AT 23 HAMPSHIRE ST

City of Portland, Maine - Building or Use Permit Application

Jeanie Bourke - 23 Hampshire permit

**City of Portland
Building Permit Application**

WEST ELEVATION
SCALE 1/4" = 1'-0"

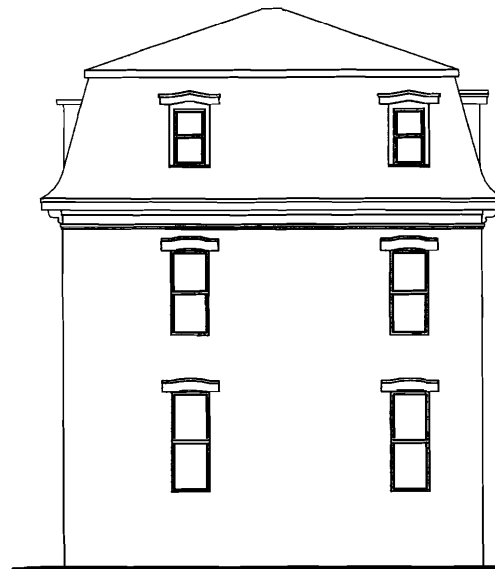
not part of
this permit.
per conversation
w/ Curtis Dow
8/24/07.

NORTH ELEVATION
SCALE 1/4" = 1'-0"

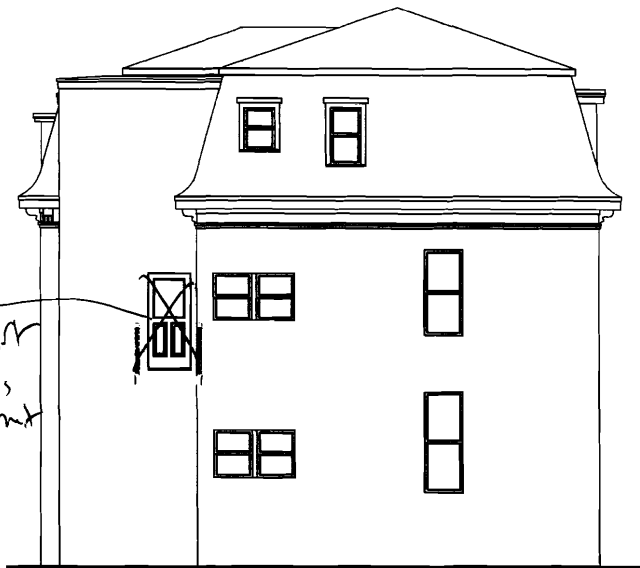
not part
of this
permit
